# Access Compliance Report

## Public Rights-of-Way

Intersection ID: 47463	Main Street: DOMINION_VILLAGE_DR	Cross Street: DOMINION_GREEN_DR	Location: SW
ADA ID: 71750E7BA45A	Ramp Type: BlendTrans1	Initial Pass/Fail: Fail	Overall Compliance: No
		Severity Score: 30

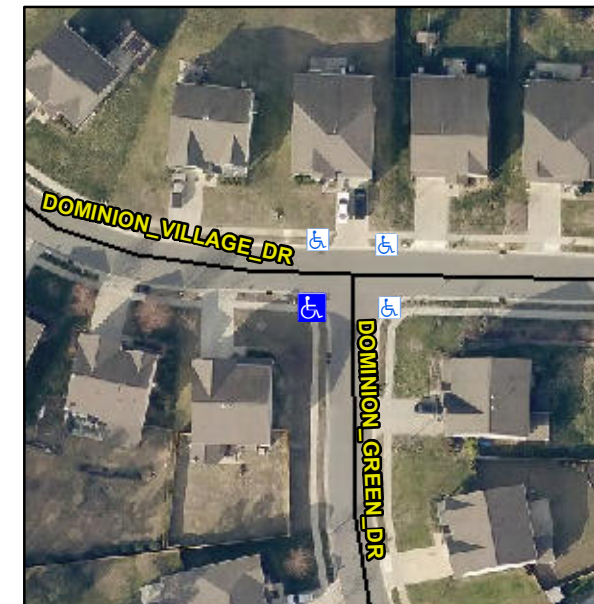
**Not Found, R304.5.1, R304.5.3**

Compliance	Description	Data	Compliance	Description	Data
N/A	Ramp Length (in)	46.0	Yes	BlendTrans Slope (%)	4.3
No	Ramp Width (in)	35.5	No	BlendTrans XSlope (%)	5.3
N/A	Flare Type LT	N/A	N/A	Flare Type RT	N/A
N/A	Flare Slope LT (%)	N/A	N/A	Flare Slope RT (%)	N/A
N/A	Flare Traversable LT?	N/A	N/A	Flare Traversable RT?	N/A
N/A	Landing Length (in)	N/A	N/A	DWS Provided?	N/A
N/A	Landing Width (in)	N/A	N/A	DWS Contrast?	N/A
N/A	Landing Slope (%)	N/A	N/A	DWS Length (in)	N/A
N/A	Landing X Slope (%)	N/A	N/A	DWS Full Width?	N/A
N/A	Landing Curb? (Y/N)	N/A	N/A	DWS Offset (in)	N/A
N/A	Shared Landing?	N/A			
N/A	Gutter Ponding?	N/A	N/A	Gutter Slope (%)	N/A
N/A	Gutter Lip Ht (in)	N/A	N/A	Gutter X Slope (%)	N/A
N/A	Painted X Walk1?	No	N/A	Painted X Walk2?	No
	X Walk 1 Direction	To E		X Walk 2 Direction	To N
	X Walk 1 Width (in)	N/A		X Walk 2 Width (in)	N/A
	X Walk 1 Slope (%)	4.1		X Walk 2 Slope (%)	1.4
	X Walk 1 X Slope (%)	1.9		X Walk 2 X Slope (%)	4.7

N/A	Ramp inside XWalk1?	N/A	N/A	Ramp inside XWalk2?	N/A
	Road Slope (%)	5.3		Clear Space?	N/A
	Road X Slope (%)	2.7	N/A	Clear Space to XWalk (in)	N/A
N/A	Any Obstructions?	N/A	N/A	Storm Grate/Utility Hazard?	N/A
	Obstruction Type			Storm Grate/Utility Type	
		N/A			N/A
			Yes	Surface Condition? (G/P)	Good
			No	Curb Slope (%)	6.3

**Remove & Replace Curb Ramp With Two New Directional Ramps or Equivalent.**
